ADA Curb Ramp New Construction Inspection Form (Perpendicular)

Main

24952.54

Wascoe

PERPENDICULAR RAMP (PR)

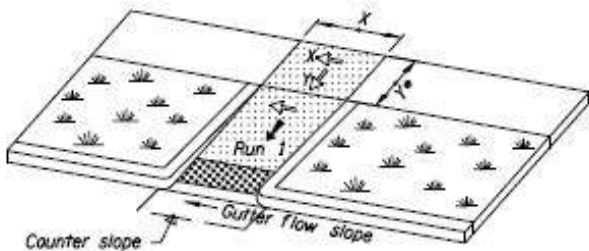
IITD gt2. Vert drop.
